November 14, 2022

ADDENDUM NUMBER 2
TO THE DRAWINGS AND SPECIFICATIONS

PROJECT: Lincoln Central Elementary School HVAC Renovation

A/E PROJECT NO: 25821422

PROJECT NO. 25821422
 ISSUE DATE 10/25/2022
 SHEET E.1.1

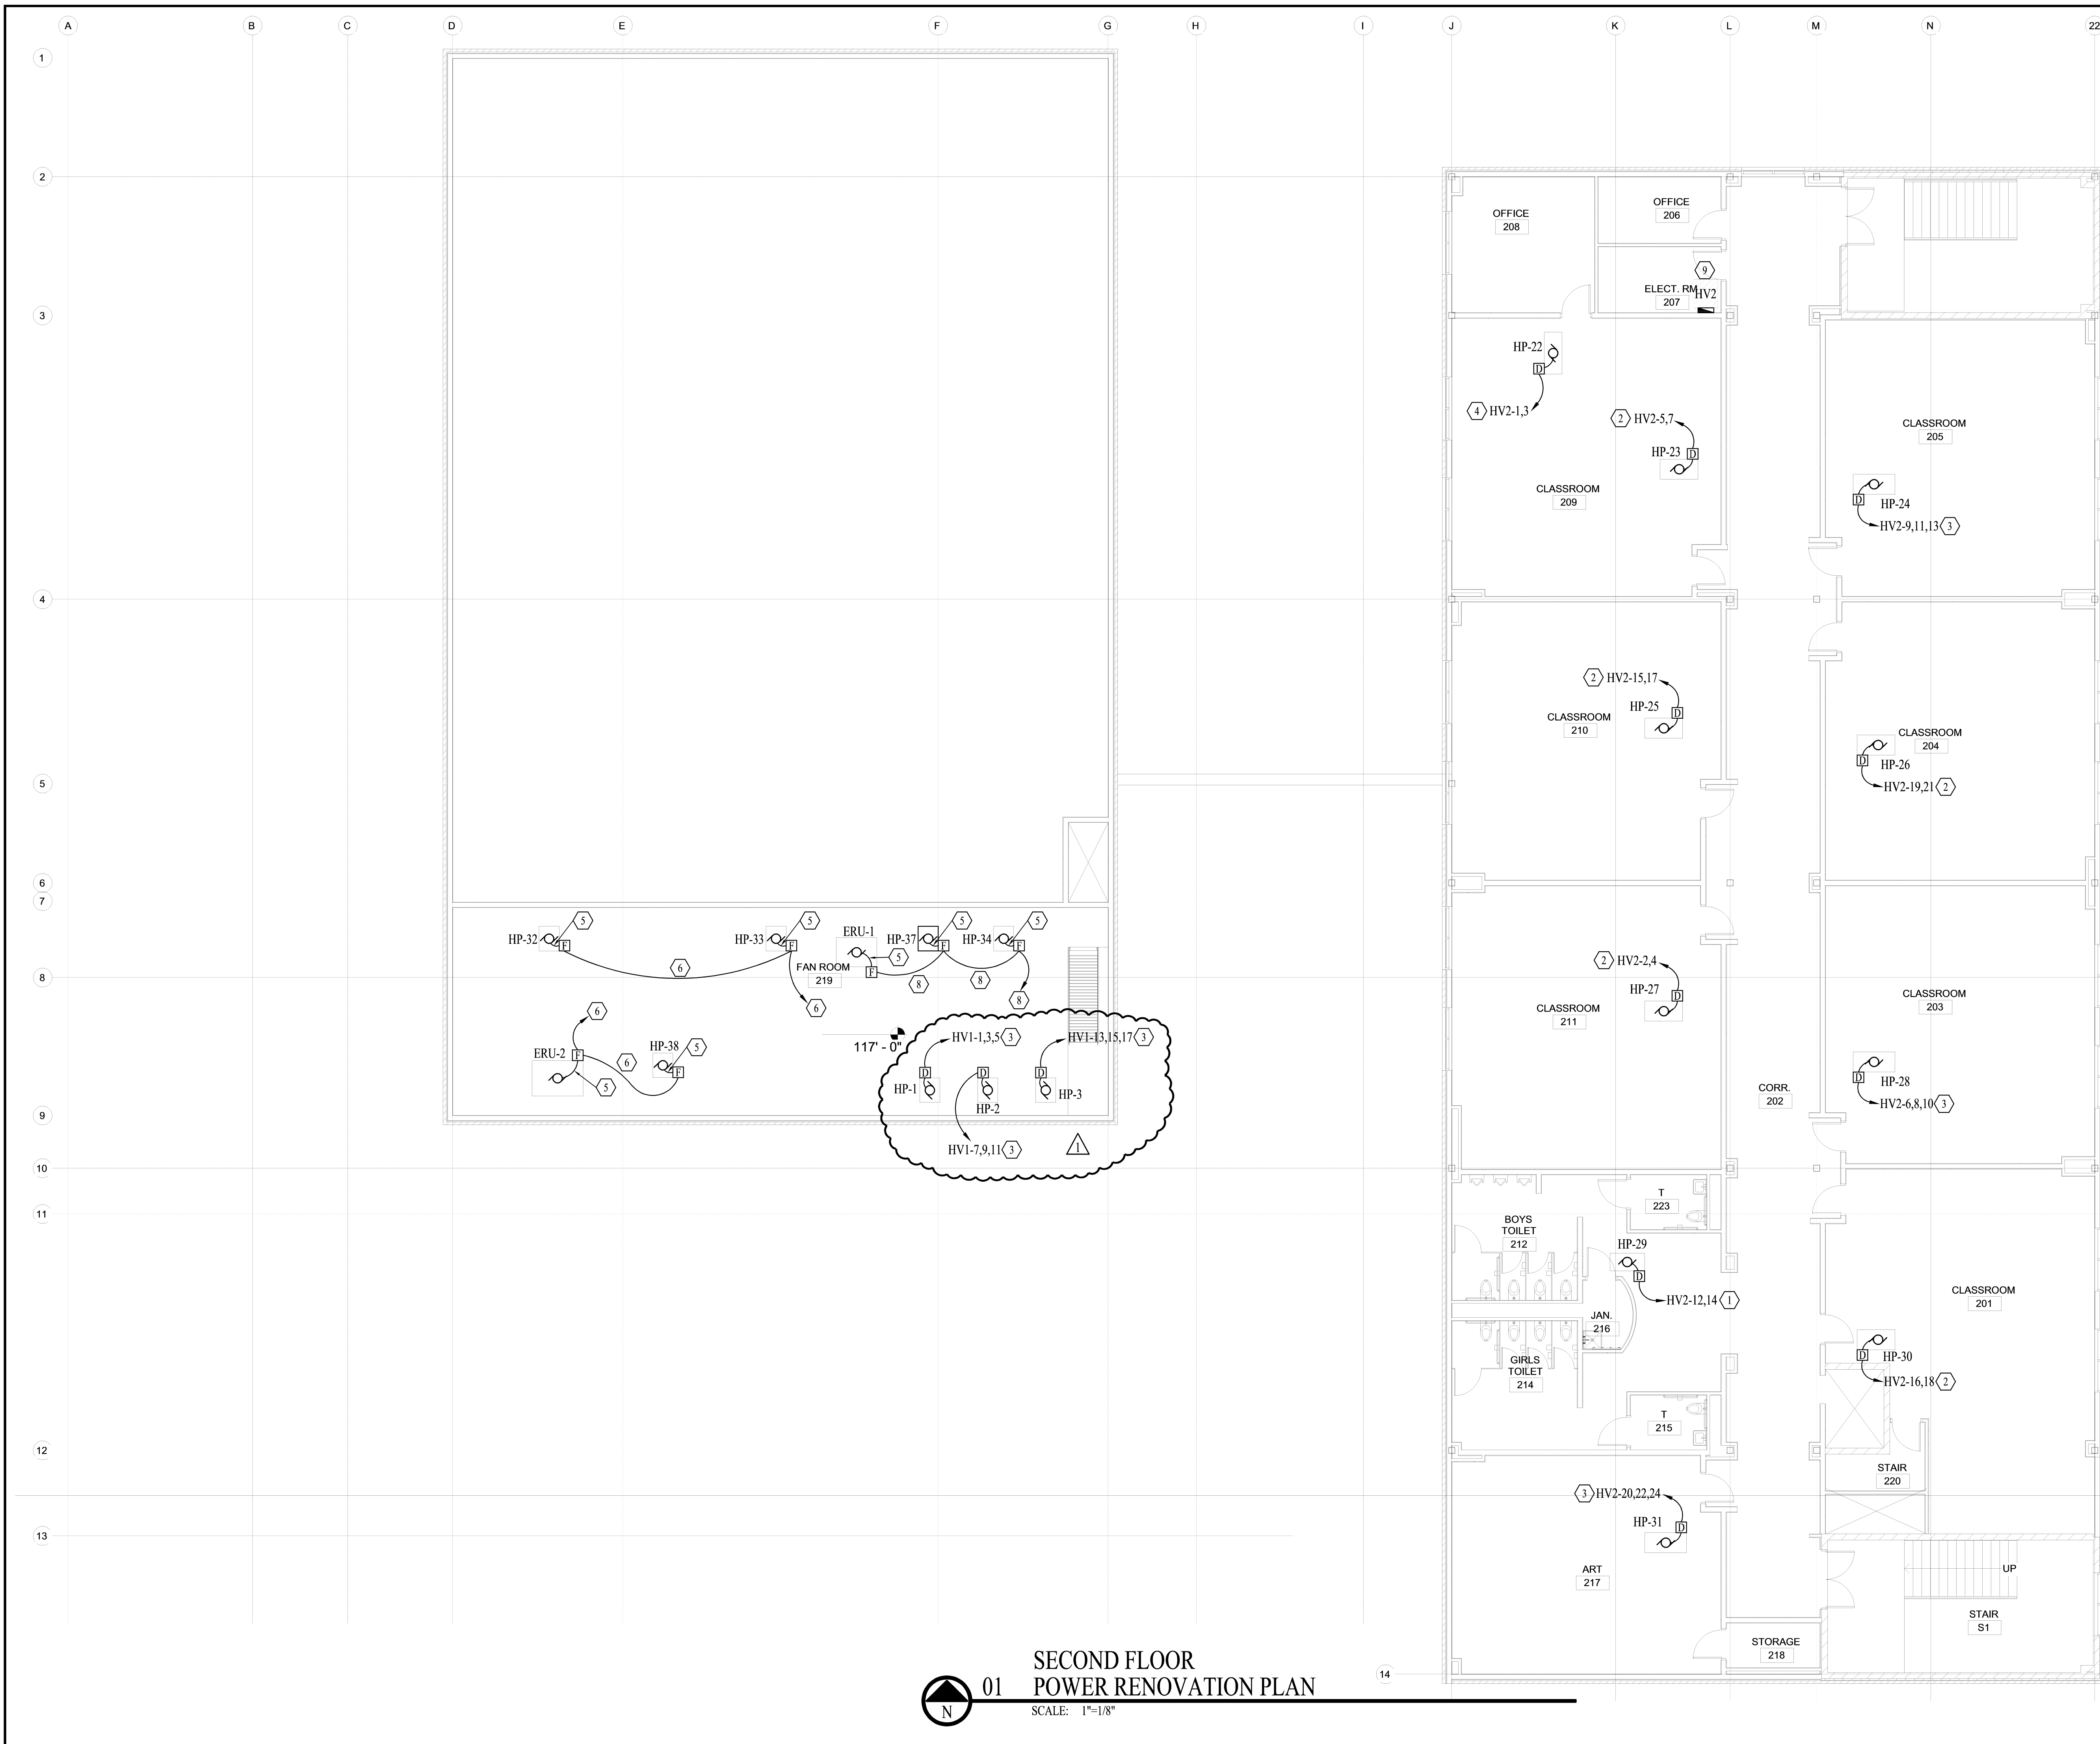
8. TO THE DRAWINGS; Sheet E1.1: Show power for new electric unit heaters in mechanical room, electrical room, and storage.
9. TO THE DRAWINGS; Sheet E1.3: Show power for relocated heatpumps HP-1, HP-2, and HP-3 in the upper mechanical room adjacent to the gym.

01 THIRD FLOOR MECHANICAL RENOVATION PLAN
SCALE: 1"=1/8"

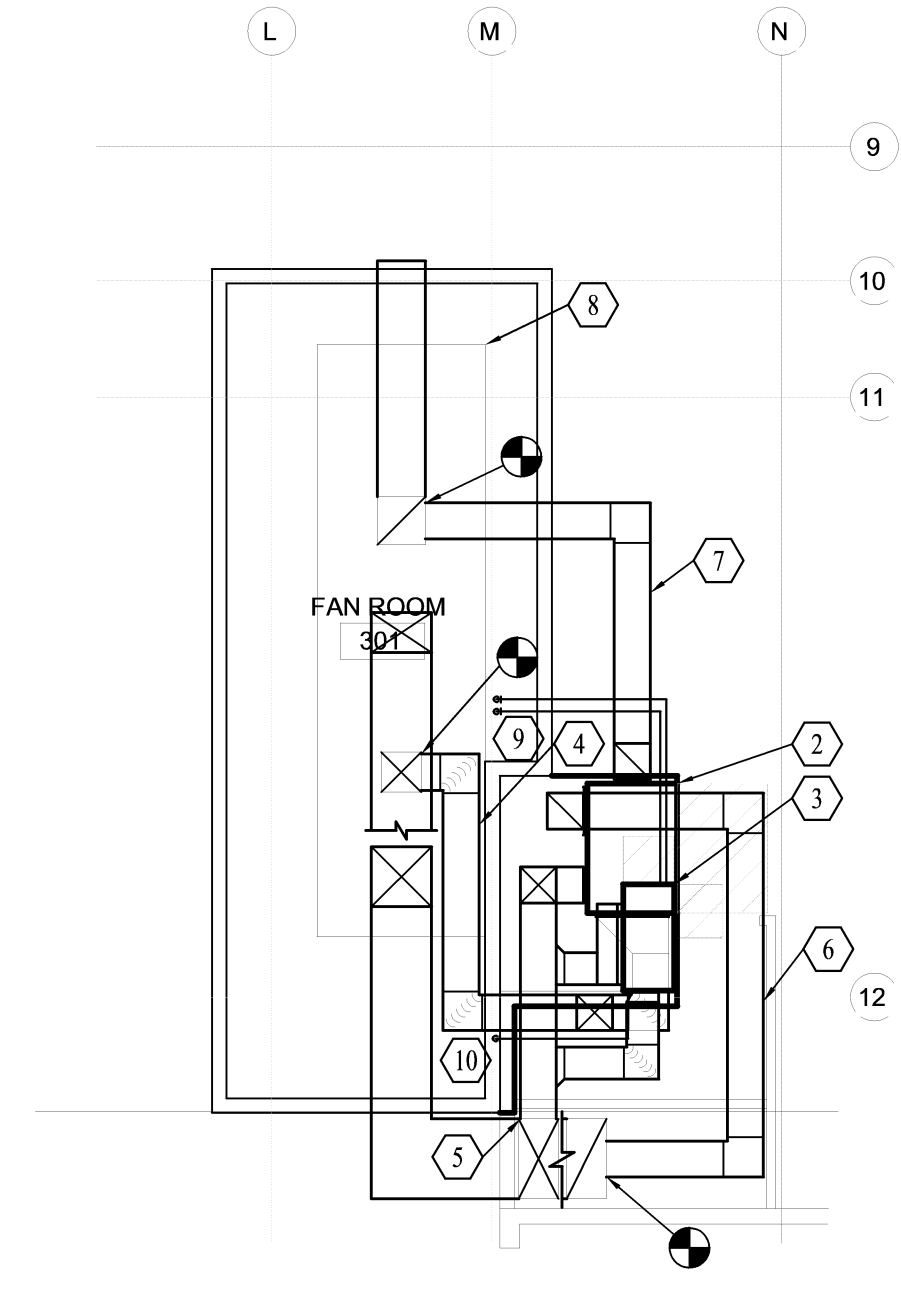
6. TO THE DRAWINGS; Sheet M1.3: Show revised location for HP-1, HP-2, and HP-3 in the upper mechanical room adjacent to the gym.
7. TO THE DRAWINGS; Sheet M4.1: Add the schedule for the electric unit heaters.

PROJECT NO. 25821422
ISSUE DATE 10/25/2022
SHEET M1.1

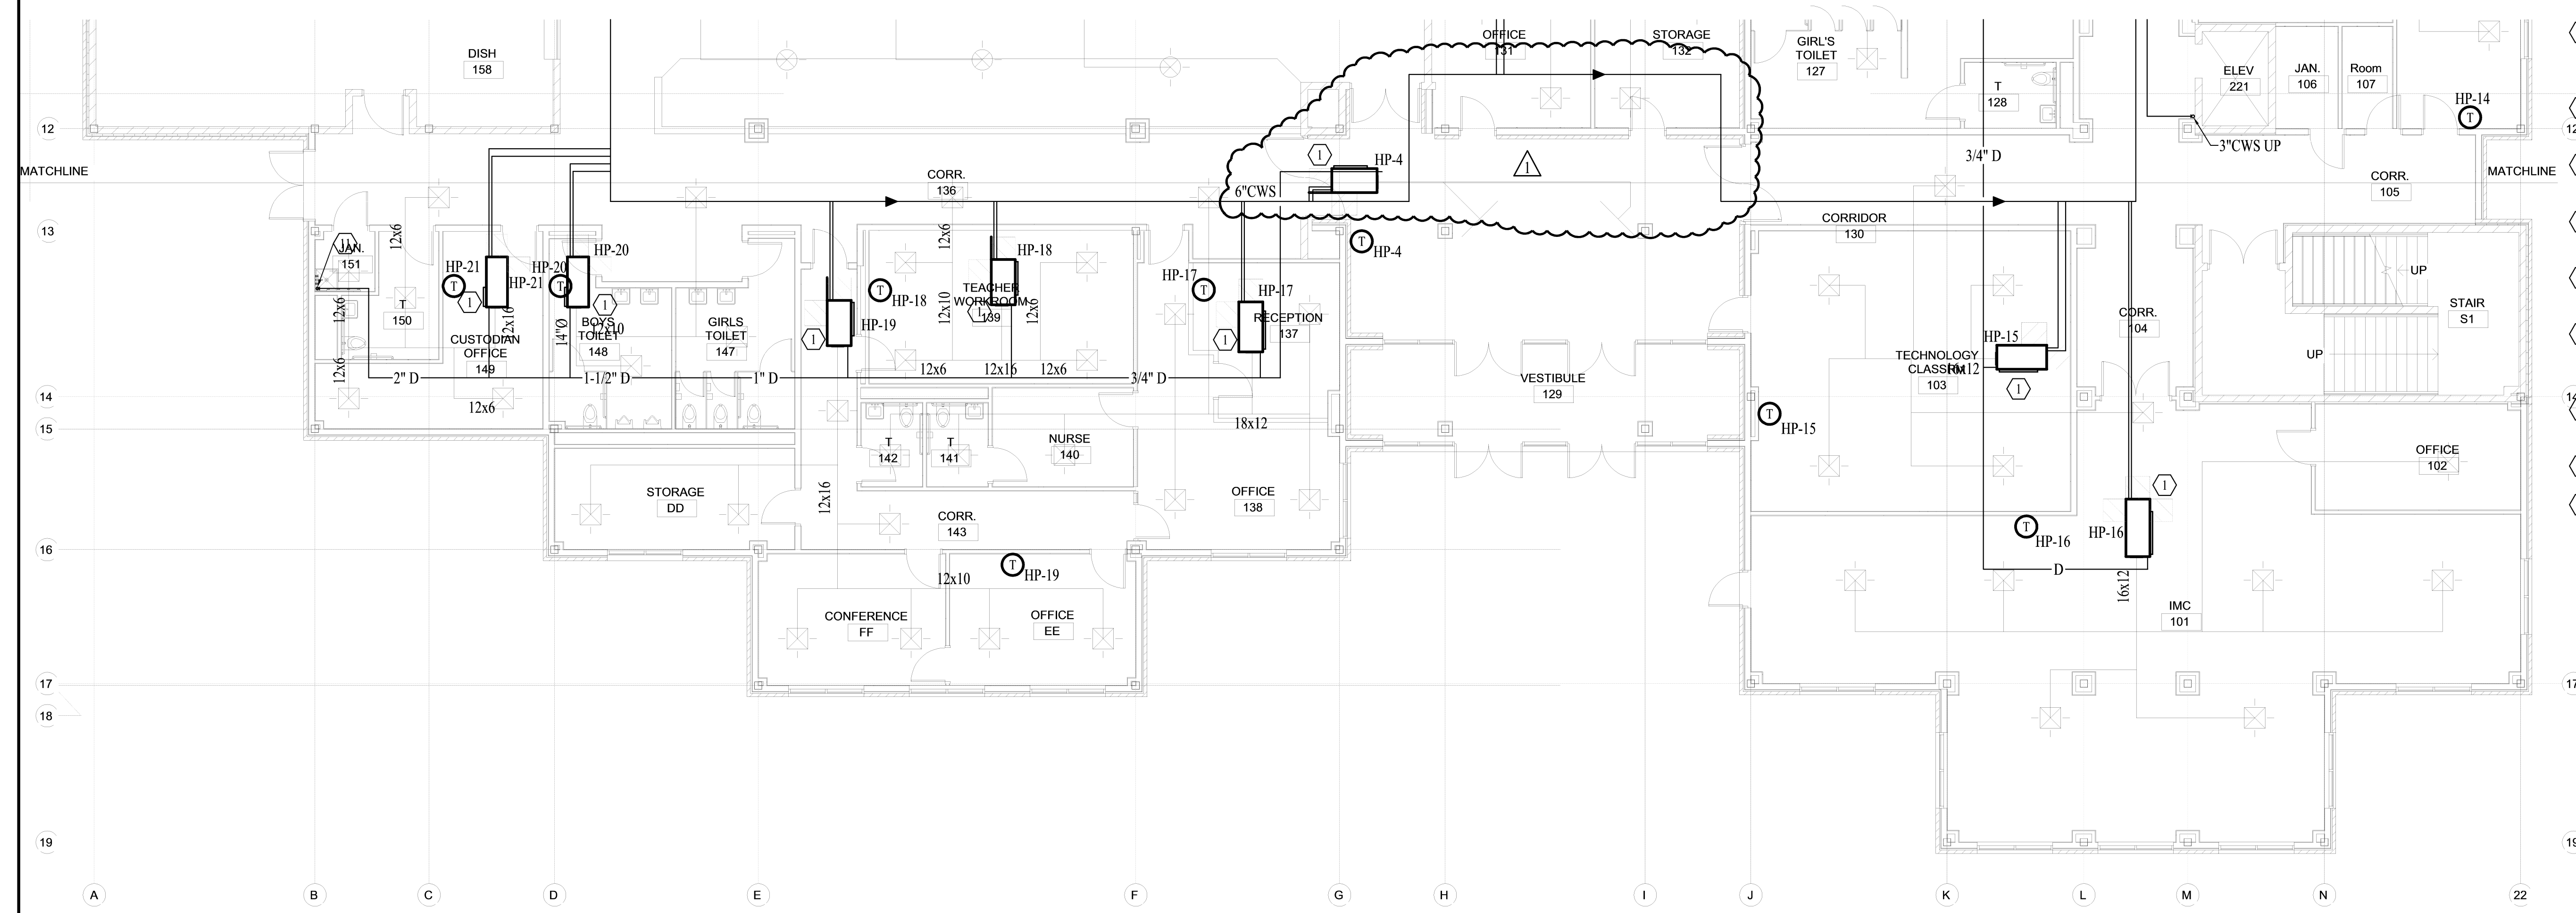
5. TO THE DRAWINGS; Sheet M1.1: Revised loop piping routing around main entrance. Revised loop piping in East corridor and into the upper mechanical room adjacent to the gym. Relocate heat pumps HP-1, HP-2, and HP-3 into the upper mechanical room adjacent to the gym. This adds 88' of 12" x 24" duct to three heat pumps that need to be painted 1 coat flat black paint. Added four electric unit heaters in mechanical room, electrical room, and storage to replace removed hydronic unit heaters.

PROJECT # 25821422
 ISSUED DATE 10/25/2022
 SHEET
A801
 OF SHEETS

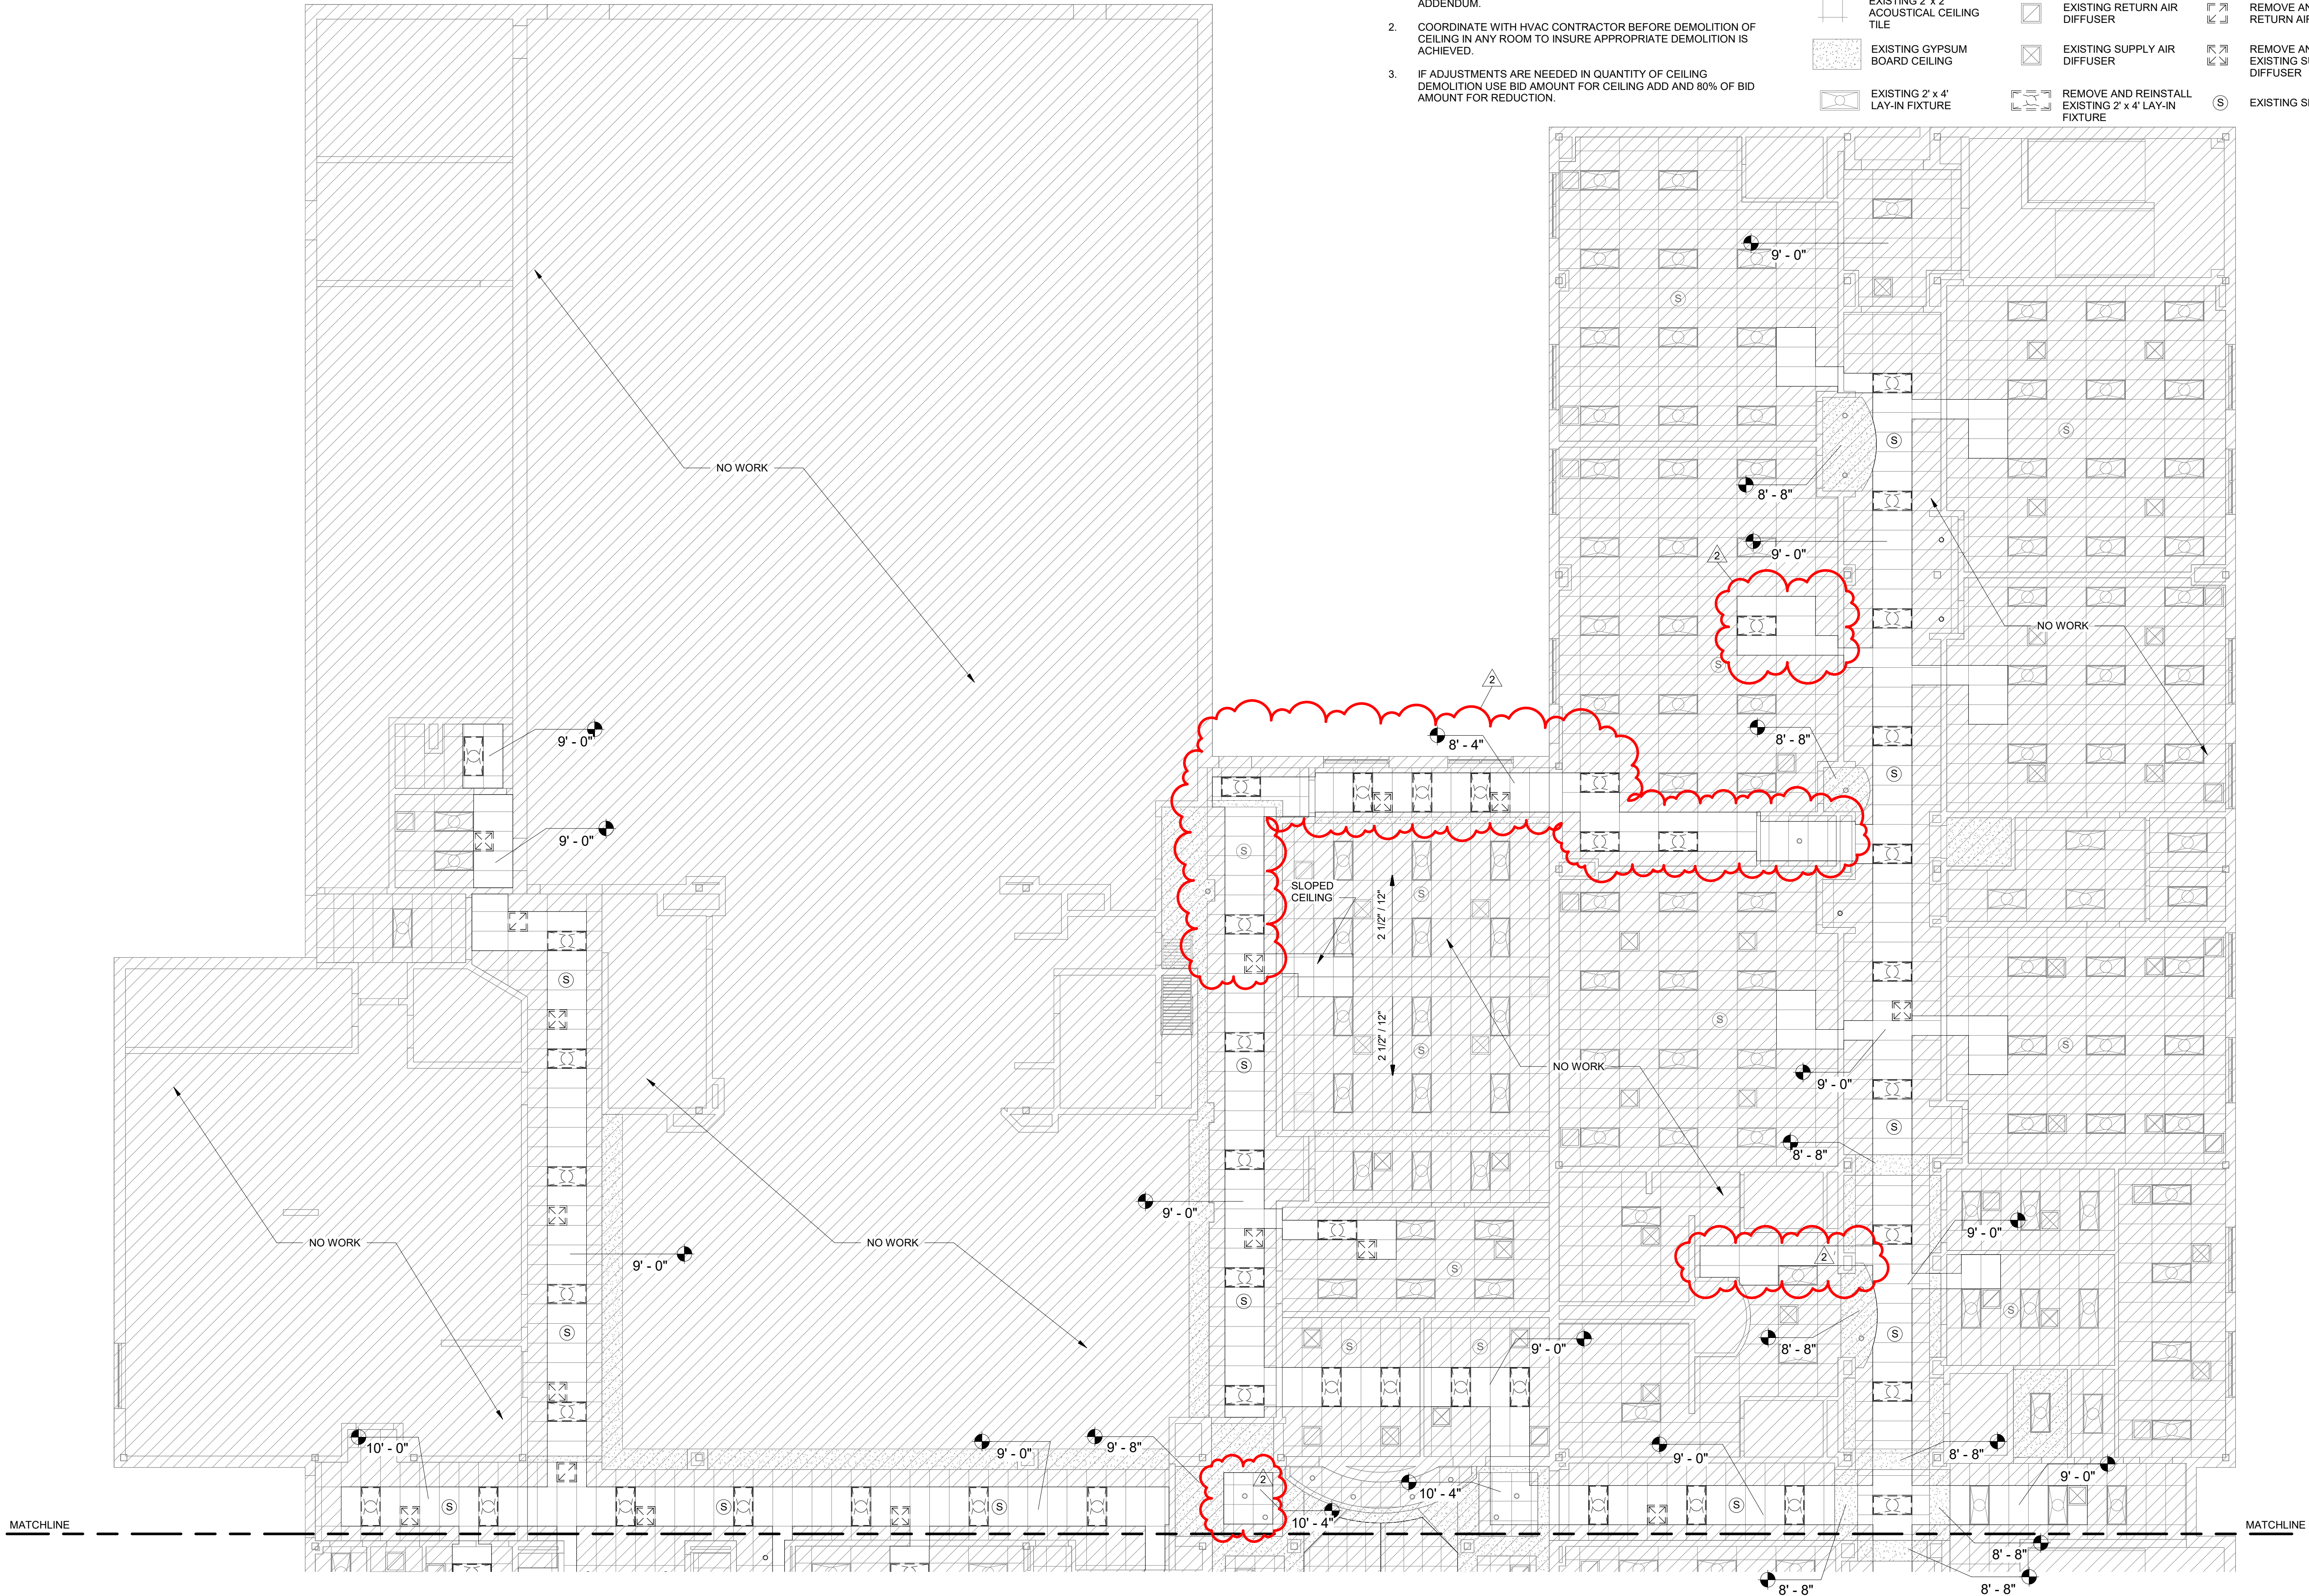
10. TO THE DRAWINGS; Sheet A801 & Sheet A803: Add ceiling removal and

replacement as shown on new A801 and A803 sheet.

11. TO THE DRAWINGS; Sheet M1.2: Delete original Sheet M1.2. Replace with attached Sheet M1.2.
12. TO THE DRAWINGS; Sheets A801, A802, and A803: With the ceiling removal shown, there may be 2 security cameras to be reinstalled and 12 exit fixtures reinstalled.
